APPLICATION NO.	FILING DATE	FIRST NAMED INVENTOR	ATTORNEY DOCKET NO.	CONFIRMATION NO.
10/743,458	12/23/2003	Tsuyoshi Kubota	90606.2/wa	8146
54071	7590	04/11/2007		
YAMAHA HATSUDOKI KABUSHIKI KAISHA C/O KEATING & BENNETT, LLP 8180 GREENSBORO DRIVE SUITE 850 MCLEAN, VA 22102			EXAMINER KIM, CHONG HWA	
			ART UNIT 2167	PAPER NUMBER

Office Action Summary	Application No. 10/743,458	Applicant(s) KUBOTA ET AL.	
	Examiner Chong H. Kim	Art Unit 2167

DETAILED ACTION

FIG. 19

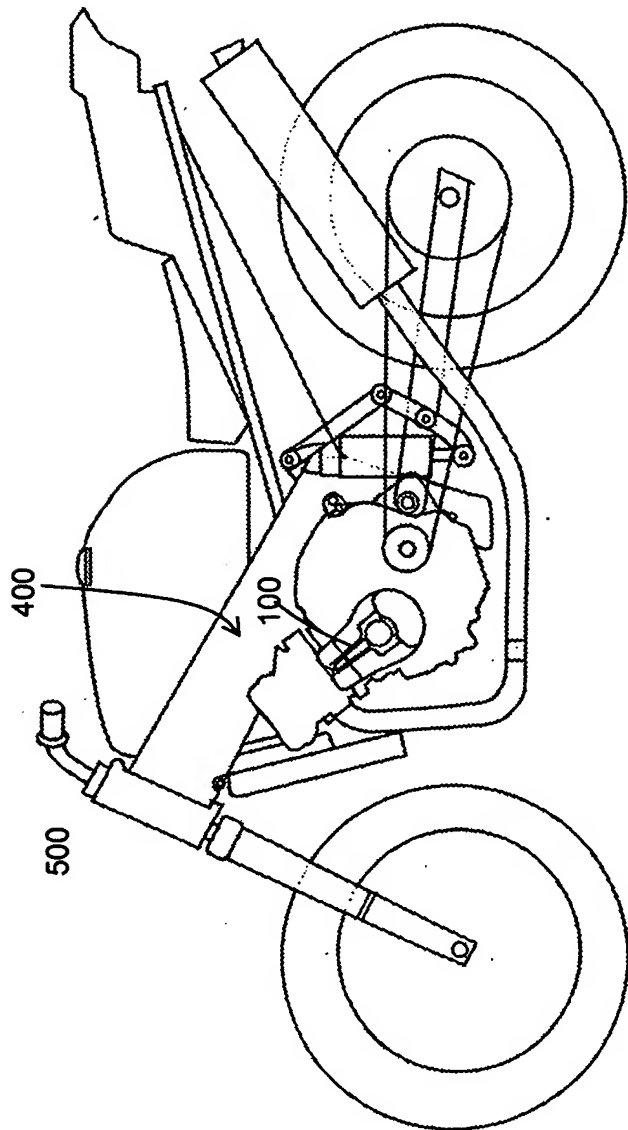
1. The drawing was received on Feb 7, 2007. The drawing is not approved for containing new matter.
2. The drawings are objected to under 37 CFR 1.83(a). The drawings must show every feature of the invention specified in the claims. Therefore, the engine as recited in claims 23 and 31; and the vehicle as recited in claims 24 and 32 must be shown or the feature(s) canceled from the claim(s). No new matter should be entered.

3. The amendment filed Feb 7, 2007 is objected to under 35 U.S.C. 132(a) because it introduces new matter into the disclosure. 35 U.S.C. 132(a) states that no amendment shall introduce new matter into the disclosure of the invention. The added material which is not supported by the original disclosure is as follows: Fig. 19 as submitted in the drawing and the new paragraph on page 10 line 26 to indicate such illustration.

not approved ca 4/6/07

Applicant is required to cancel the new matter in the reply to this Office Action.
